Project: City of Coos Bay – Egyptian Theatre Restrooms

Date: July 11, 2013

Issued By: Sy Allen, PE – ZCS Engineering, Inc.

### PROJECT ADDENDUM #3

**ADD3-1**

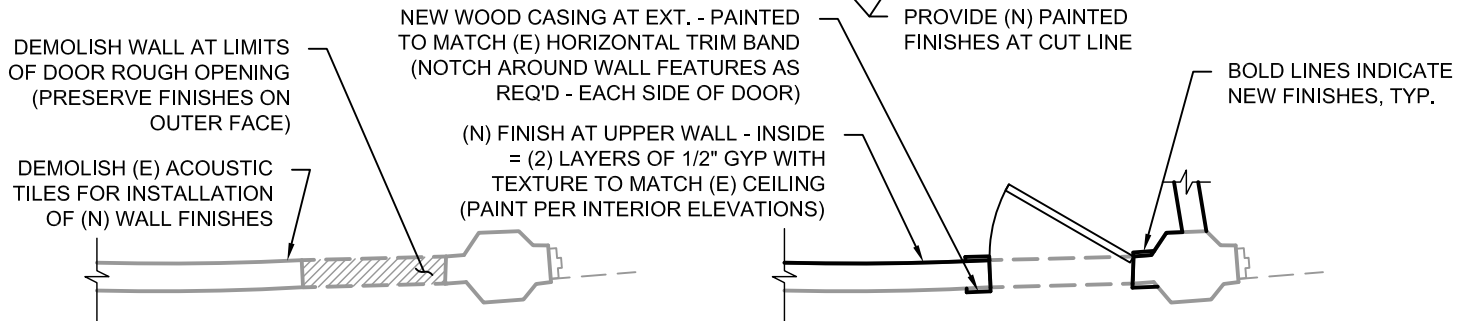
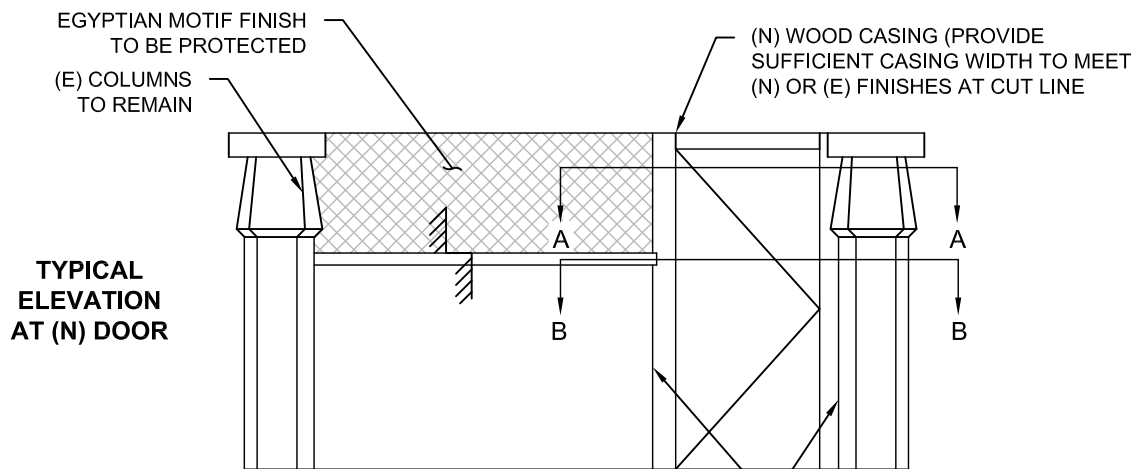
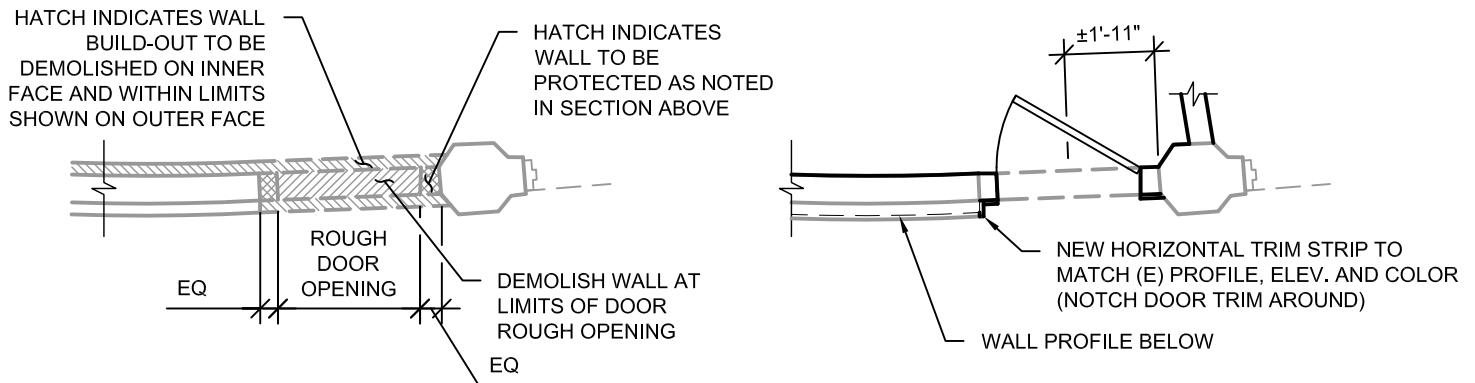
1. Sheet Add3-1 shall be added to the contract drawings as part of the plan set. This sheet contains clarifications on the construction and detailing of the changes to the existing wall at the new restroom. All features of construction shown on this sheet apply or are similar for restroom #2.
2. Mechanical sheets M-2, M-3, and M-3.1 have been updated to reflect changes to exhaust routing and ceiling construction.
3. Electrical sheet E-4 has been updated to reflect changes to lighting fixture re-installation.

1. PROVIDE NEW FINISHES TO MATCH (E) AT RETURN OF HORIZONTAL TRIM BAND AND WALL RETURN BELOW (SEE SECTION 'B-B') ASSUMED FINISH IS PAINTED PLASTER - FIELD VERIFY.
2. ALL FEATURES OF CONSTRUCTION NOT SHOWN TO BE PER ORIGINAL CONTRACT DOCUMENTS. IF CONFLICTS OCCUR, NEW DOCUMENTS SHALL SUPERCEDE OLDER DOCUMENTS. CONTACT ZCS ENGINEERING IN THE CASE OF FIELD CONFLICTS.
3. SUBMIT MOCK-UP OF FINISH TEXTURE W/ PAINT FOR APPROVAL PRIOR TO PATCHING/FINISH OPERATIONS.
4. G.C. TO PROVIDE FIELD INSTALLED WOOD CASING OVER METAL DOOR FRAME IN FIELD - PROVIDE NON-SHRINK CAULK FROM CASING TO FRAME. PAINT FRAME AND CAULK IN FIELD TO MATCH ADJACENT FINISHES - COLOR BREAK FROM INSIDE TO OUT TO OCCUR AT DOOR.

M-2

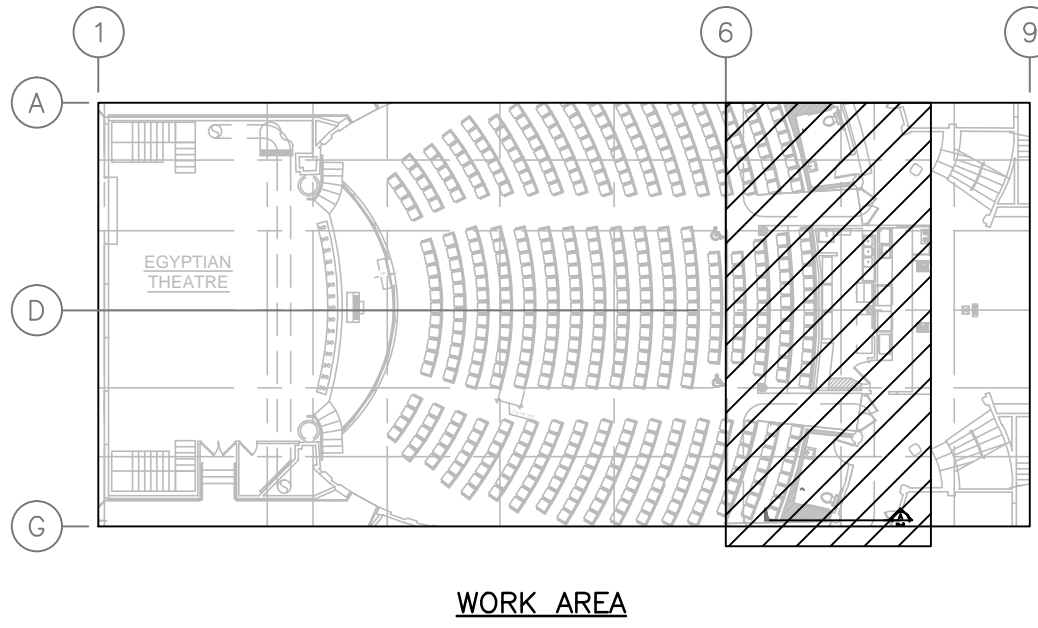
RELOCATE EXISTING 18x24 (APPROX.) RETURN AIR GRILLE AND RETURN AIR DUCT ABOVE CEILING TO CORRIDOR AS SHOWN.

E-4

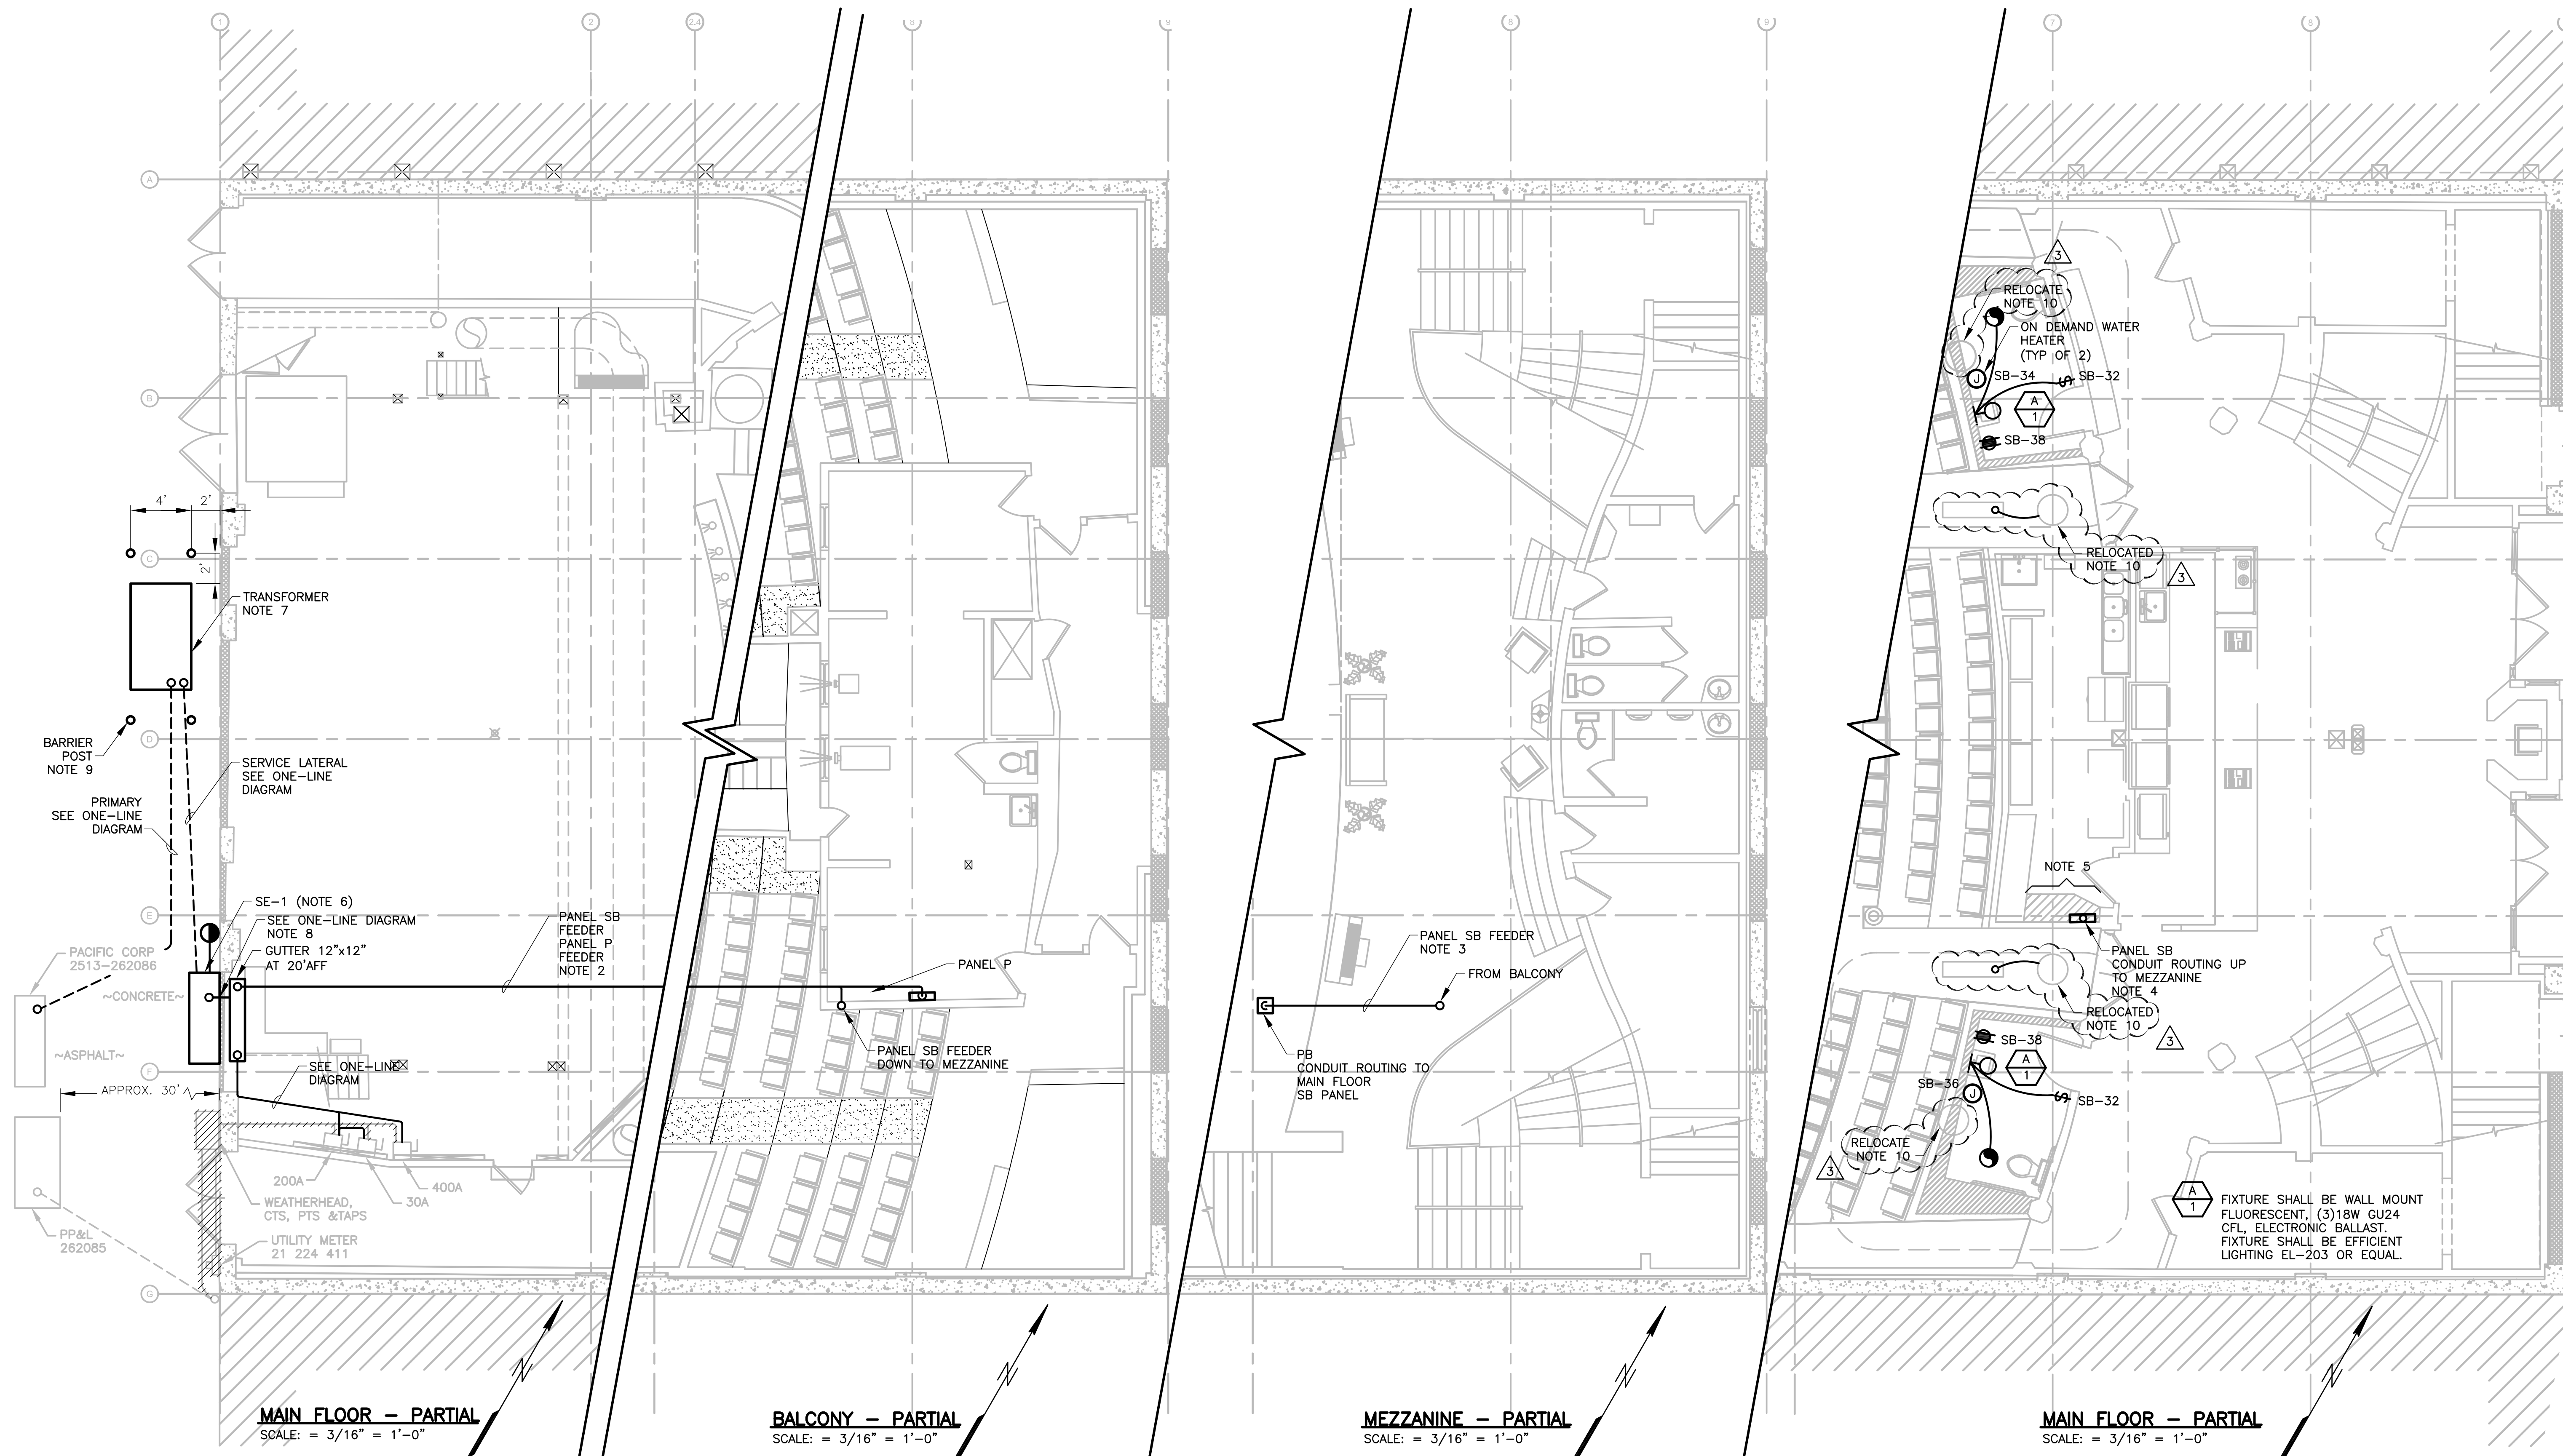
10. CONTRACTOR SHALL CAREFULLY REMOVE, PRESERVE AND PROTECT THE EXISTING CIRCULAR STYLIZED LIGHT FIXTURE WHICH WILL INTERFERE WITH THE CONSTRUCTION OF THE NEW BATHROOM WALLS. FIXTURES SHALL BE RELOCATED WITH A NEW BRANCH CIRCUIT FROM THE EXISTING 1"x4" FLUORESCENT FIXTURES AS SHOWN ON PLANS.
